UNITED STATES
NUCLEAR REGULATORY COMMISSION
WASHINGTON, D. C. 20555
October 3, 1986

Subject: Issuance of Amendment No. 31 to Facility Operating License
No. NPF-22 - Susquehanna Steam Electric Station, Unit 2

Amendment No. 31
License No. NPF-22

ATTACHMENT TO LICENSE AMENDMENT NO. 31

MAXIMUM AVERAGE PLANAR LINEAR HEAT
GENERATION RATE (MAPLHGR) VERSUS
AVERAGE PLANAR EXPOSURE
GE FUEL TYPES 8CR183 (1.83% ENRICHED)
FIGURE 3.2.1-1

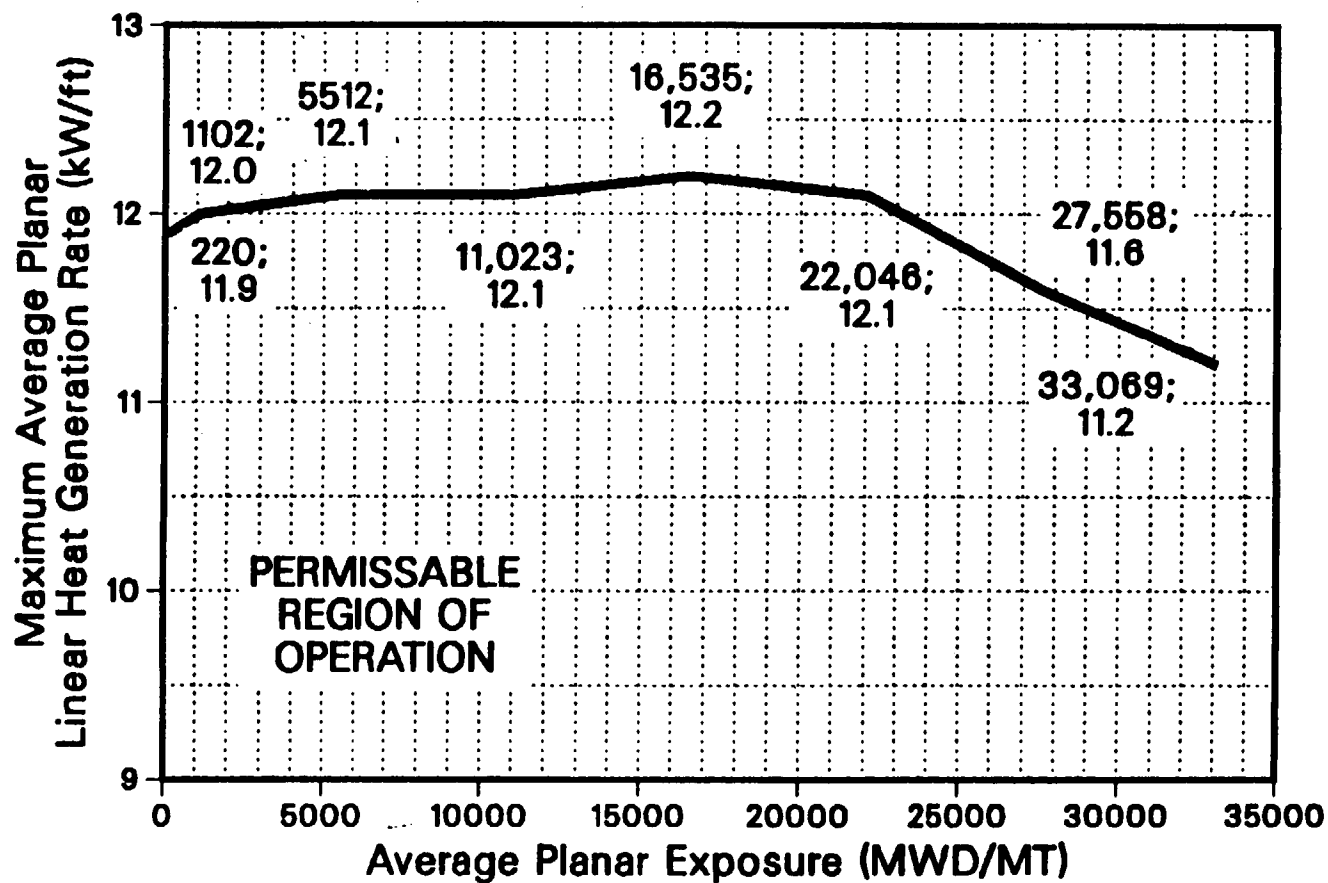
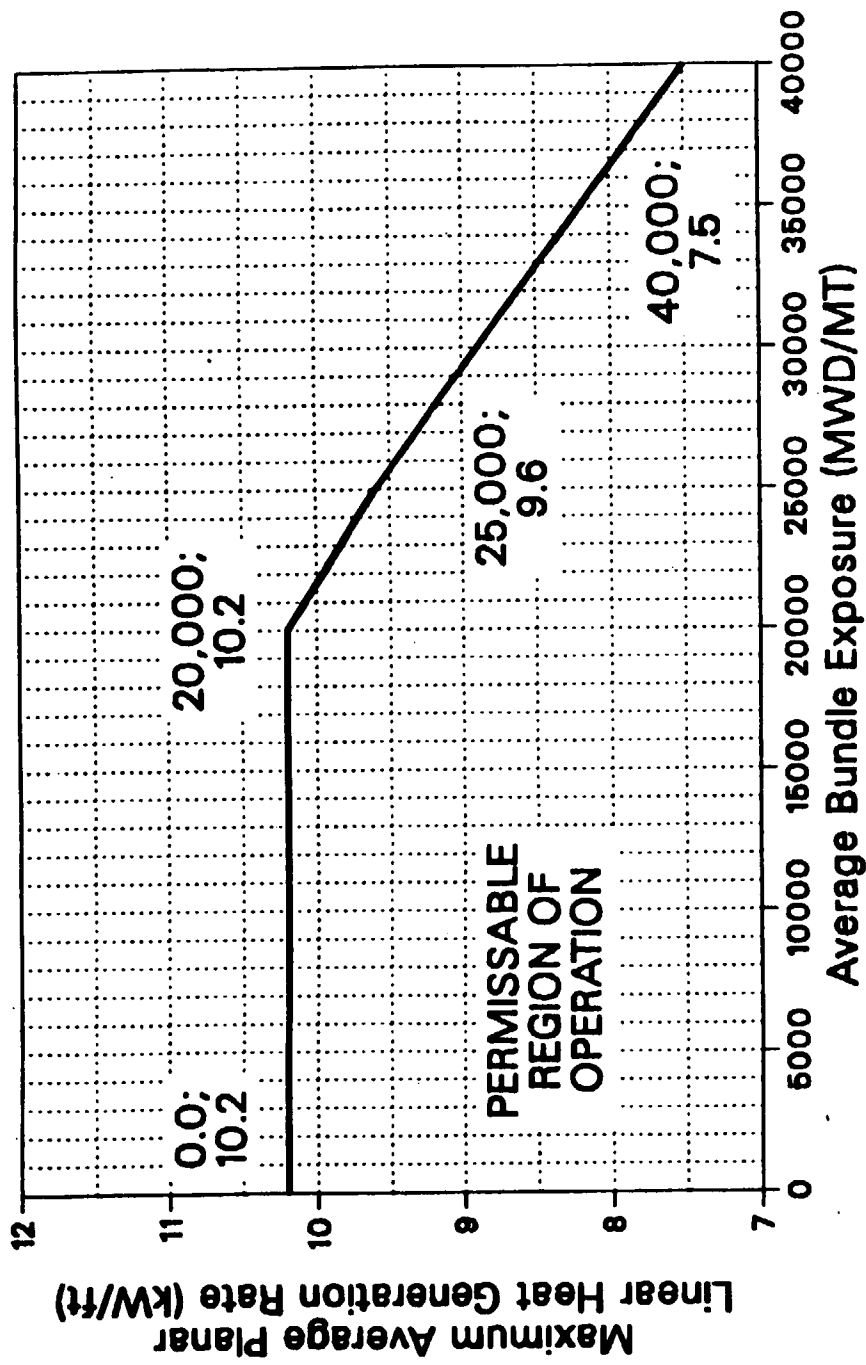
MAPLHGR values for the new ENC 9X9 fuel type were added and burnup limits were adjusted for the earlier GE fuel types. MCPR safety limits were added for the new fuel and retained for the previous 8X8 fuel types. Additional MCPR operating limits were specified for Manual Flow Control and Automatic Flow Control for all fuel types. The previous TS Figures 3.2.3-1 and 3.2.3-2 were updated to reflect the new information.

LINEAR HEAT GENERATION RATE FOR APRM SETPOINTS
VERSUS AVERAGE PLANAR EXPOSURE
EXXON FUEL
FIGURE 3.2.2-1

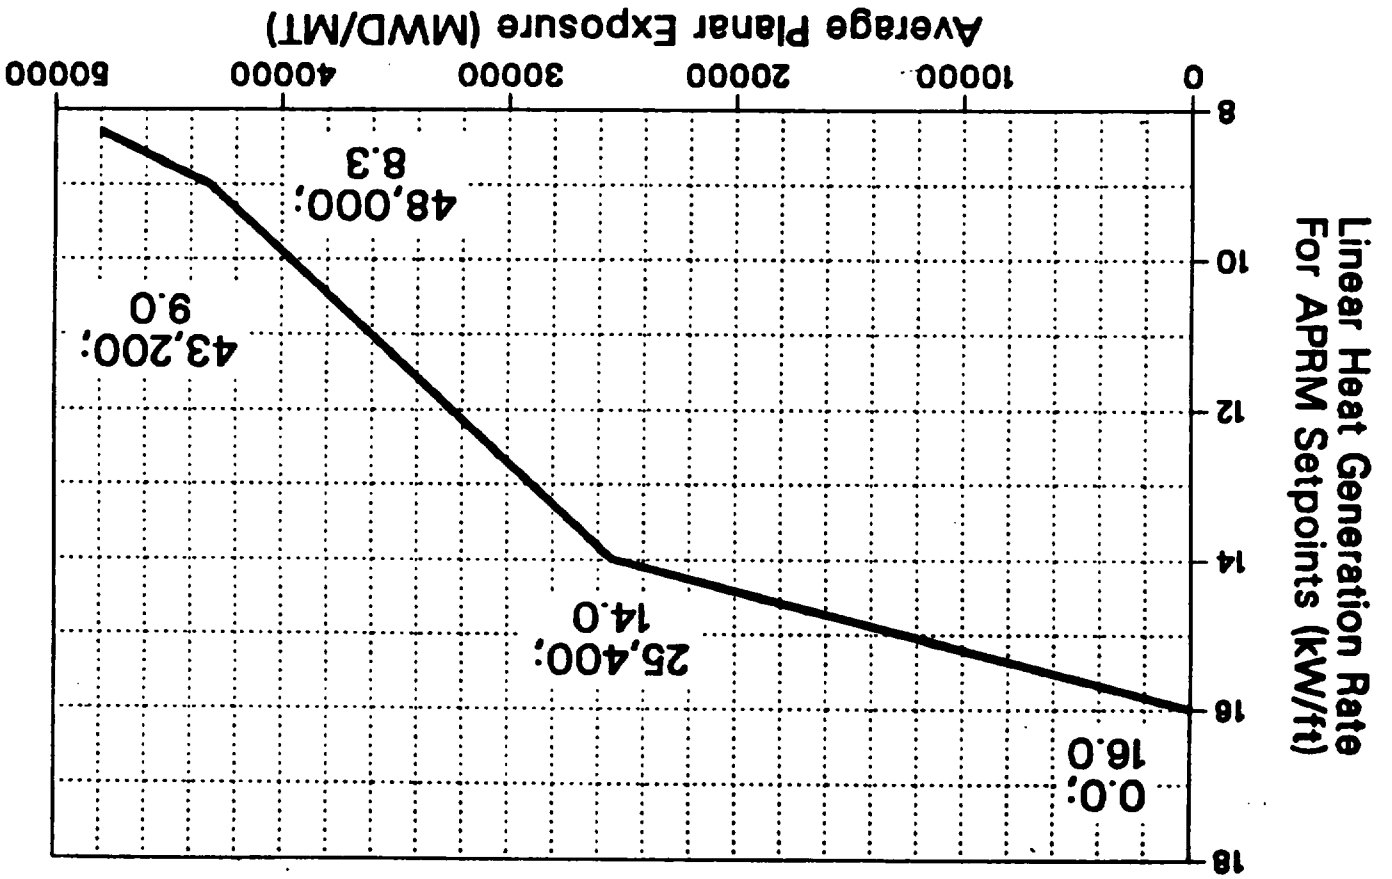
For Exxon fuel the T factor used to adjust the APRM setpoints is based on the FLPD calculated by dividing the actual LHGR by the LHGR obtained from Figure 3.2.2-1. The LHGR versus exposure curve in Figure 3.2.2-1 is based on Exxon's Protection Against Fuel Failure (PAFF) line shown in Figure 3.4 of XN-NF-85-67, Revision 1. Figure 3.2.2-1 corresponds to the ratio of PAFF/1.2 under which cladding and fuel integrity is protected during AOO's.

FLOW DEPENDENT MCPR OPERATING LIMIT
FIGURE 3.2.3-1

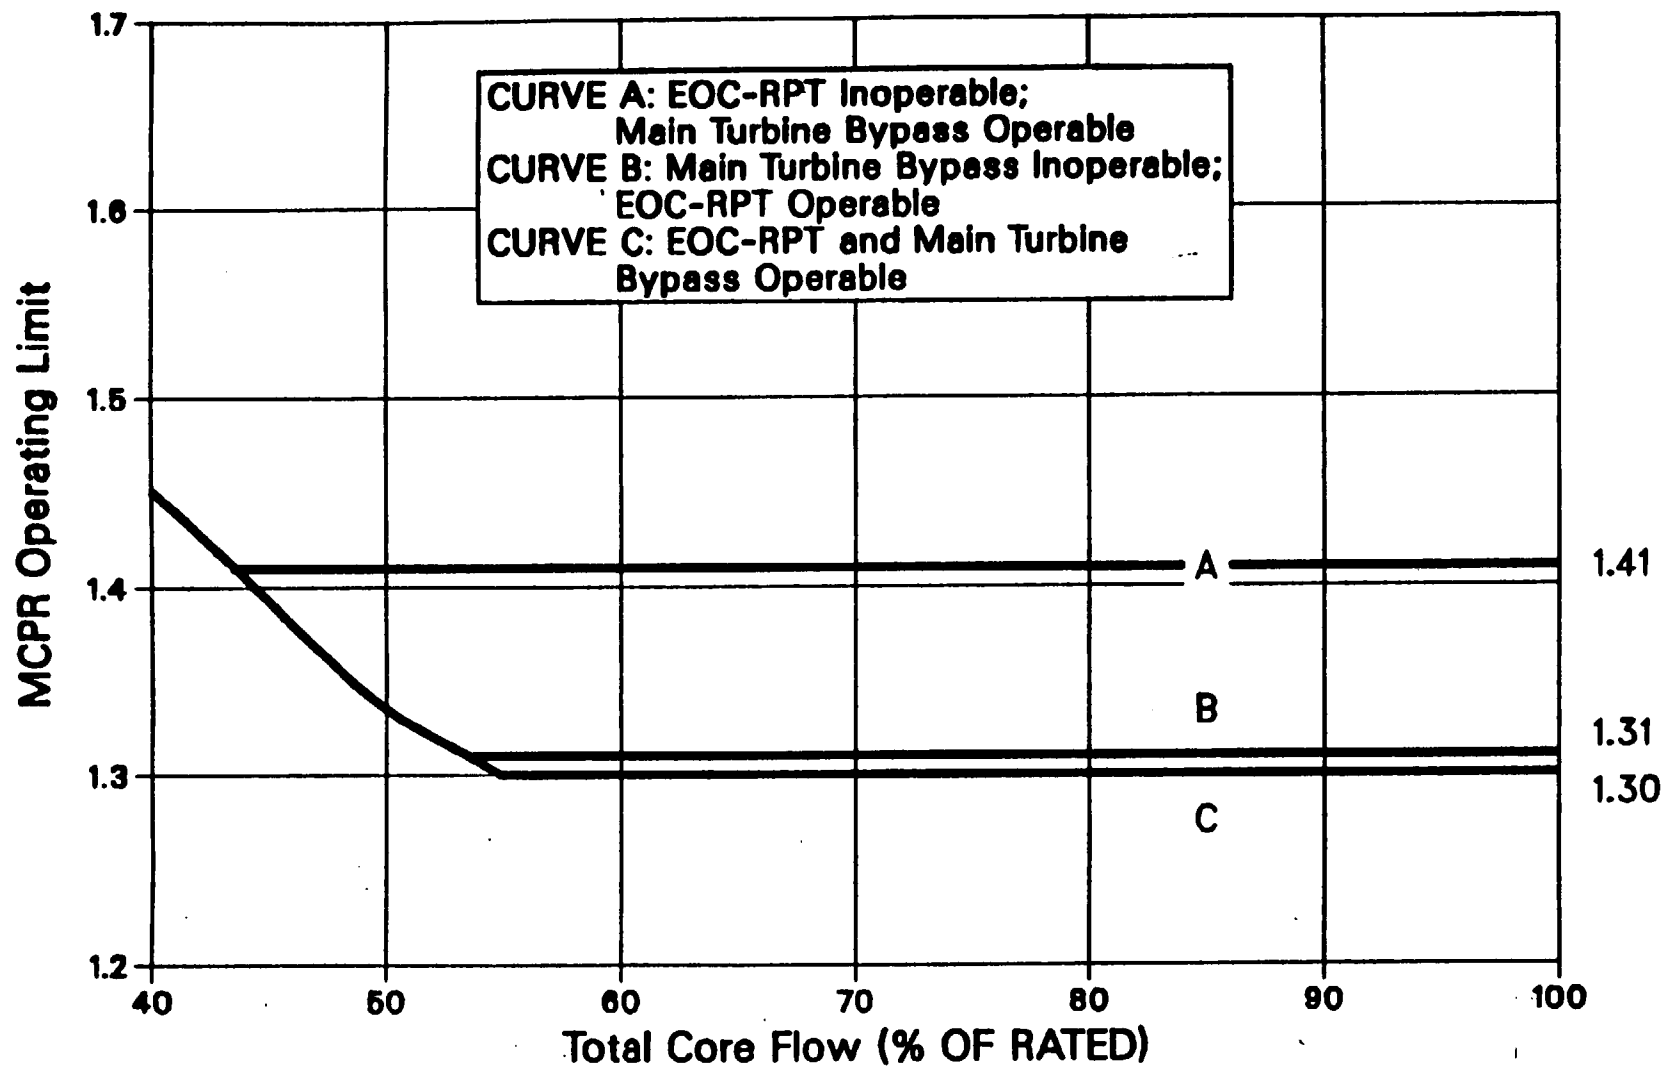
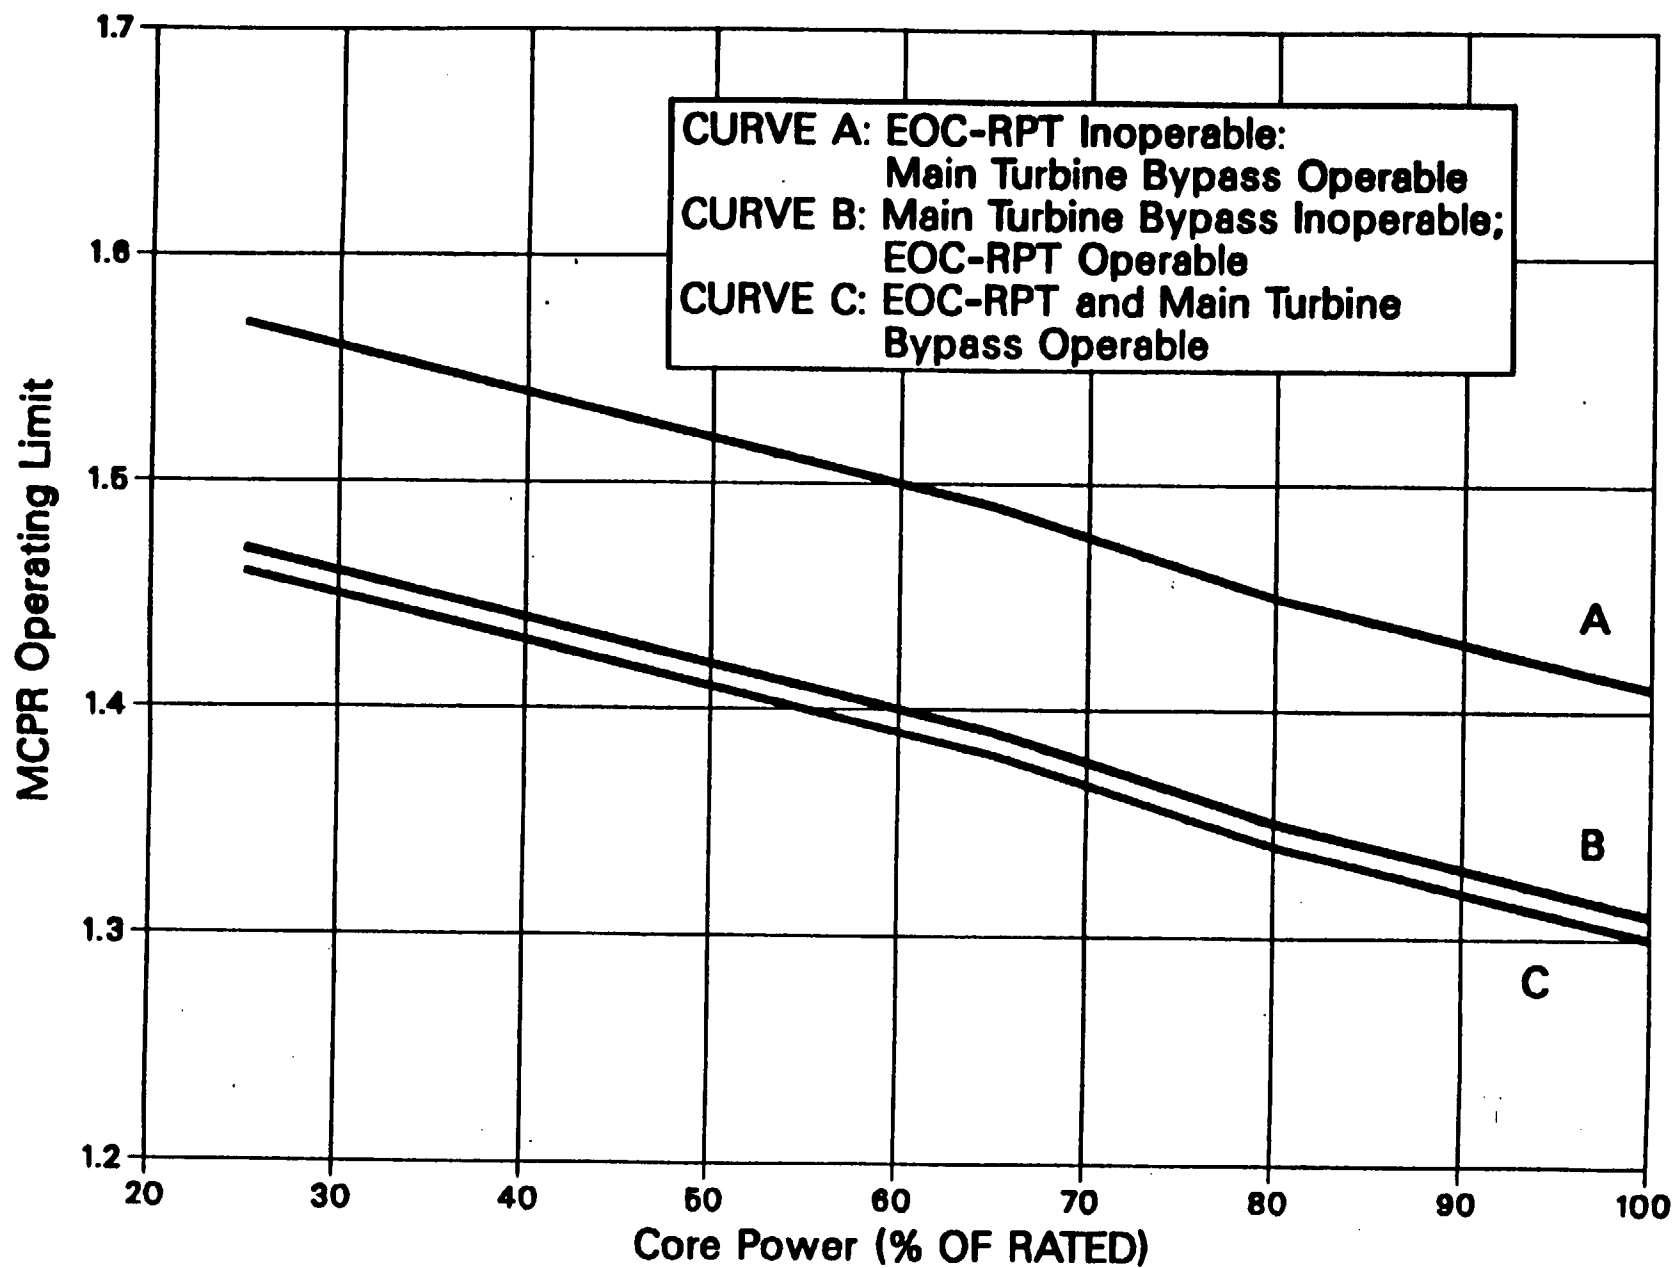
Figure 3.2.3-1 defines core flow dependent MCPR operating limits which assure that the Safety Limit MCPR will not be violated during a flow increase transient resulting from a motor-generator speed control failure. The flow dependent MCPR is only calculated for the manual flow control mode. Therefore, automatic flow control operation is not permitted. Figure 3.2.3-2 defines the power dependent MCPR operating limit which assures that the Safety limit MCPR will not be violated in the event of a feedwater controller failure initiated from a reduced power condition.

LINEAR HEAT GENERATION RATE (LHGR) LIMIT
VERSUS AVERAGE PLANAR EXPOSURE
EXXON 9X9 FUEL
FIGURE 3.2.4.2-1

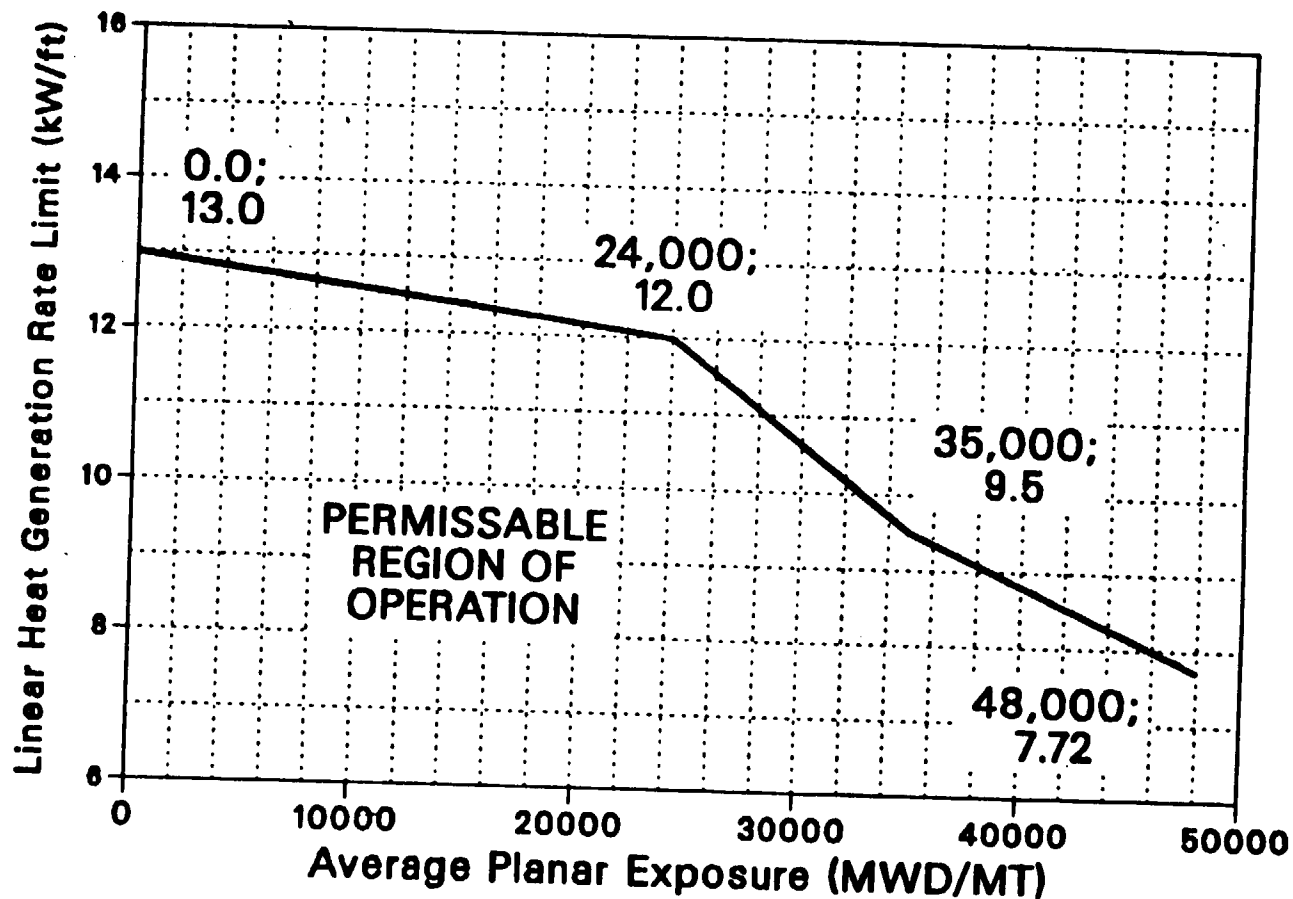
Pennsylvania Power and Light Company has provided a figure of Linear Heat Generation Rate Limit vs Planar Exposure for the ENC 9X9 fuel type to be incorporated in the Susquehanna 2 Technical Specifications (Ref. 4). This figure was approved in Reference 7 to reflect the design values which have been previously reviewed and approved for the ENC 9X9 fuel in connection with our review of XN-NF-85-67, Revision 1 (Ref. 6).
